TRANS/WP.29/GRSG/2003/22/Rev.2
20 August 2004

**PROPOSAL FOR SUPPLEMENT 1 TO THE DRAFT 02 SERIES OF AMENDMENTS TO
REGULATION No. 107**

(M2 and M3 vehicles)

Transmitted by the expert from the International Organization
of Motor Vehicle Manufacturers (OICA)

"Figure 1
ACCESS TO SERVICE DOORS

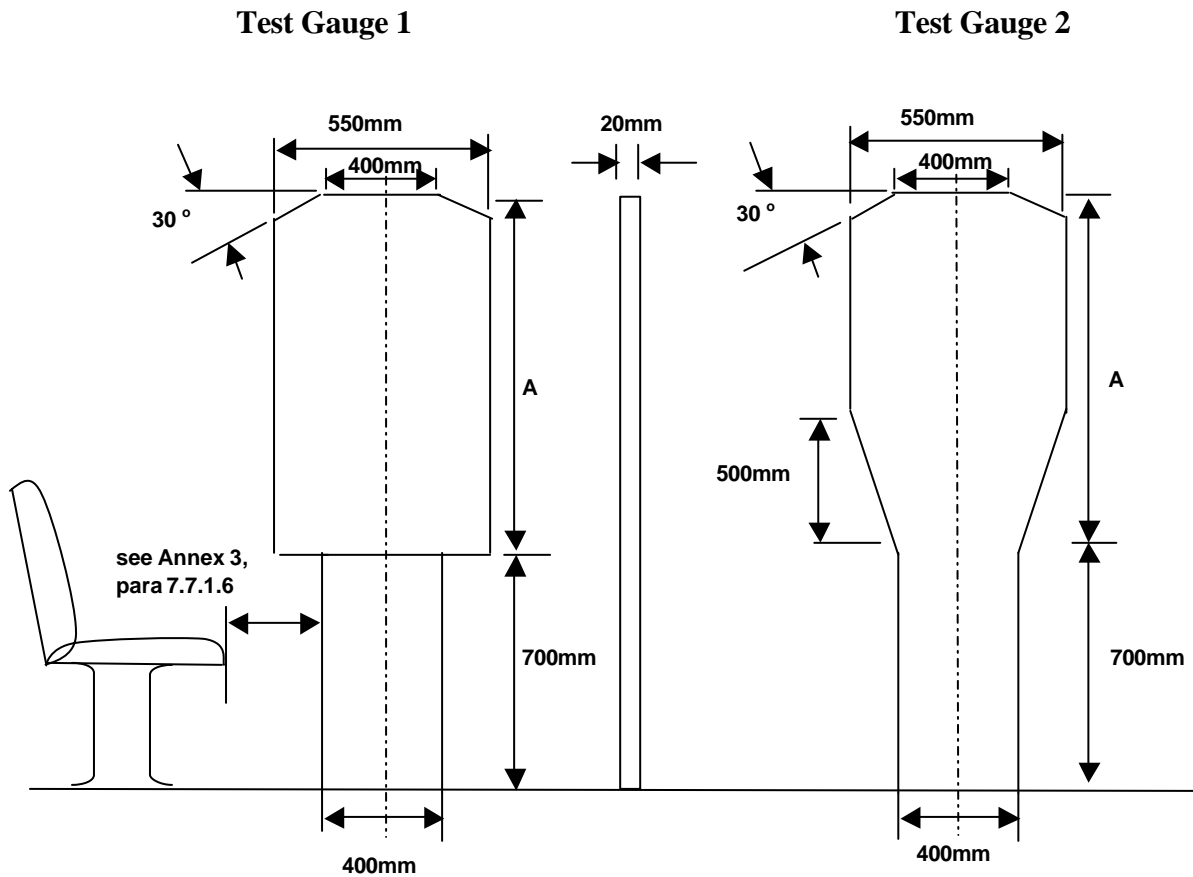
Figure 1, amend to read:

(*)For vehicles of Class A or B, the lower panel may be displaced horizontally relative to the upper panel provided that it is in the same direction."

Vehicle Class	Height of the upper panel (mm) (Dimension 'A' figure 1)	
	Test gauge 1	Test gauge 2
Class A	950 (*)	950
Class B	700 (*)	950
Class I	1100	1100
Class II	950	1100
Class III	850	1100

"Figure 11b

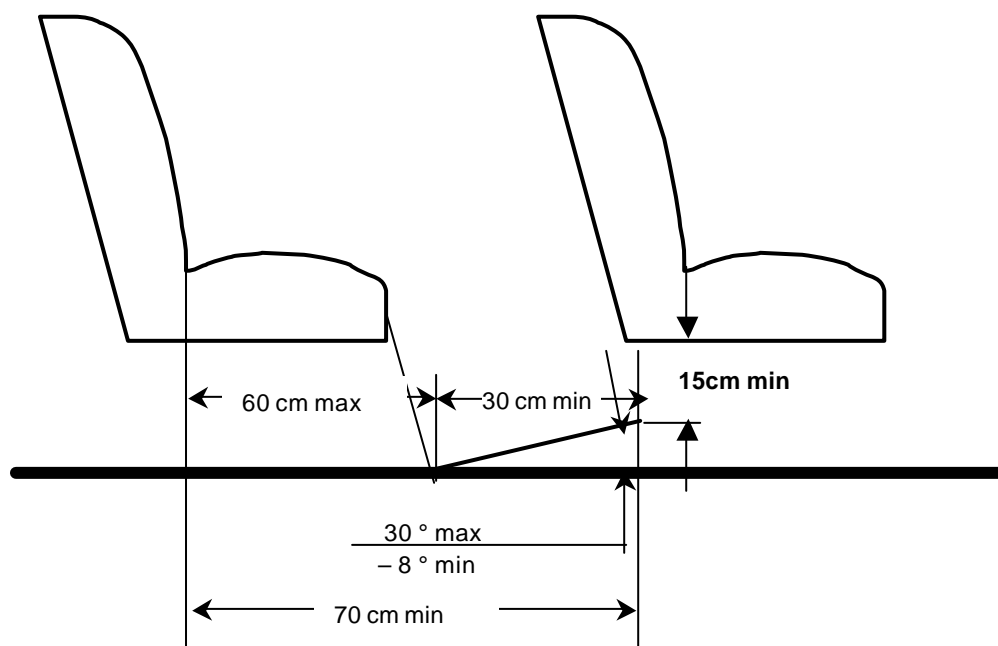
Insert a new figure 11b, to read:

**SPACE FOR FEET OF SEATED PASSENGERS BEHIND A SEAT AND OR/OR A SEAT
FACING THE GANGWAY**
(see Annex 3, paragraph 7.7.8.5.2.)

"7.7.8.5.2. For a seat behind a seat and/or a seat facing the gangway, a minimum clear foot space of at least 300 mm depth and a width according to paragraph 7.7.8.1.1., shall be provided as shown in Annex 4, figure 11b. The local presence in this space of seat legs, passenger footrests and of intrusions as provided by paragraph 7.7.8.6. shall be permitted provided that adequate space remains for the passengers' feet. This foot space may partly be situated in and/or above the gangway but shall not create any obstruction when measuring the minimum gangway-width in accordance with paragraph 7.7.5. In the case of seats alongside the driver's seat in vehicles of Class A or B, intrusion of the seat belts and seat belt anchorages shall be allowed. "

"Figure 27

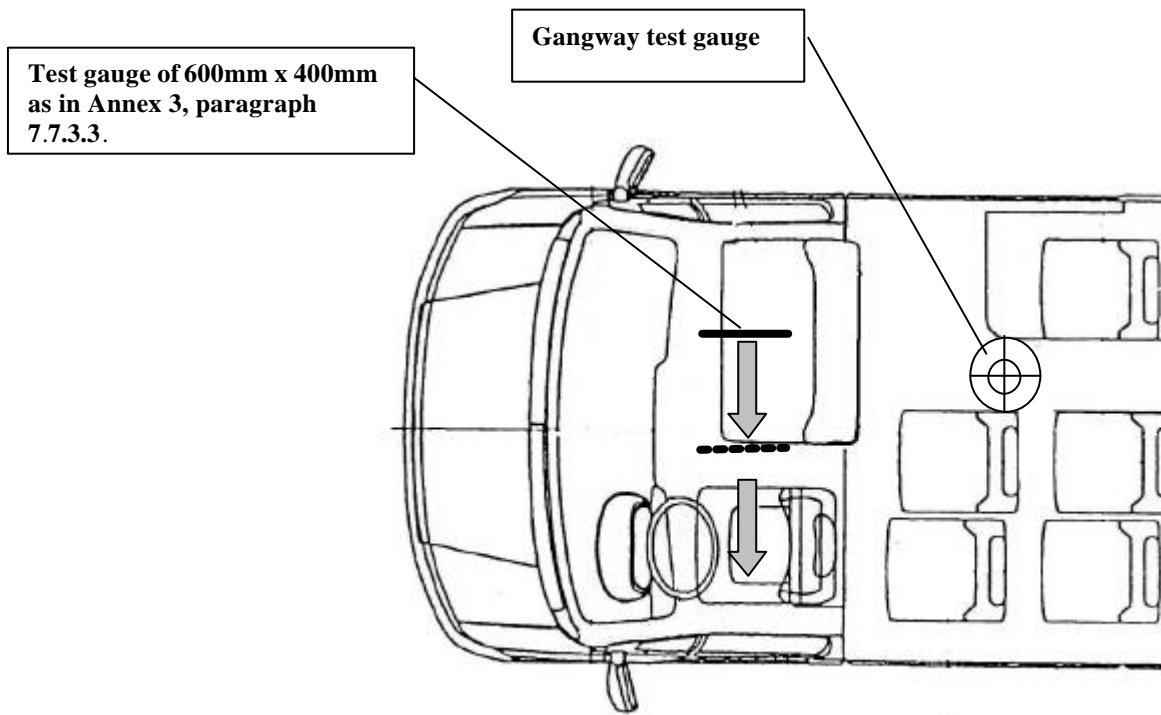
Insert new Figures 27 and 28, to read:

ACCESS TO DRIVER'S DOOR
(See Annex 3, paragraph 7.6.1.7.2.)

The driver's door shall be accepted as the emergency door for the occupants of those seats, provided that **it is possible to move a test gauge from the occupants' seats to the exterior of the vehicle through the driver's door** (see Annex 4, Figure 27).

Verification of the access to the driver's door shall be subject to the requirements of paragraph 7.7.3.2., by using the test gauge having a dimension of 600 x 400 mm, as described in paragraph 7.7.3.3.

Figure 28

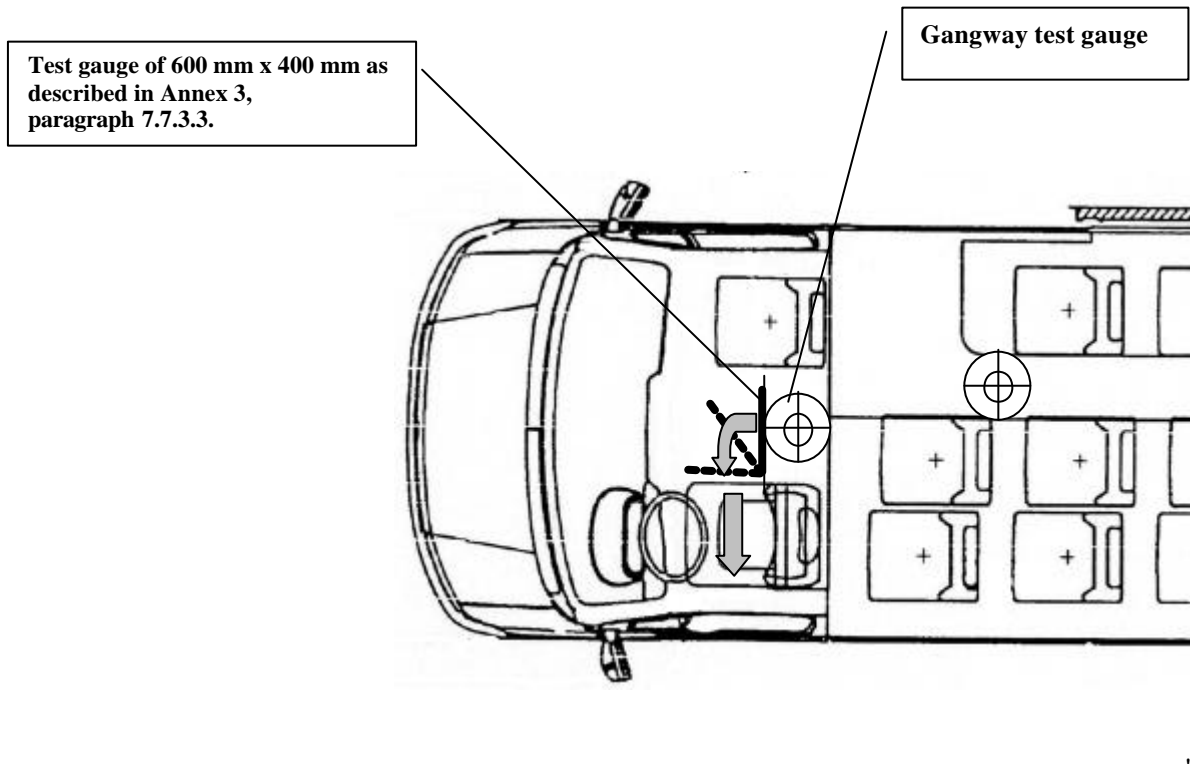
ACCESS TO DRIVER'S DOOR
(See Annex 3, paragraph 7.6.1.9.3.)

"7.6.1.9.3. **the space reserved for the driver's seat shall communicate with the main passengers' compartment through an appropriate passage; such requirement shall be deemed to be fulfilled if the test gauge described in paragraph 7.7.5.1. can move unobstructed from the gangway, until the front end of the gauge reaches the vertical plane tangential to the foremost point of the driver's seat back (this seat being situated in its rearmost longitudinal position) and, from this plane, the panel described in paragraph 7.6.1.7.2. could be moved to the emergency door in the direction established by such paragraph (see Annex 4, Figure 28) with seat and steering wheel adjustment in their mid position.**"
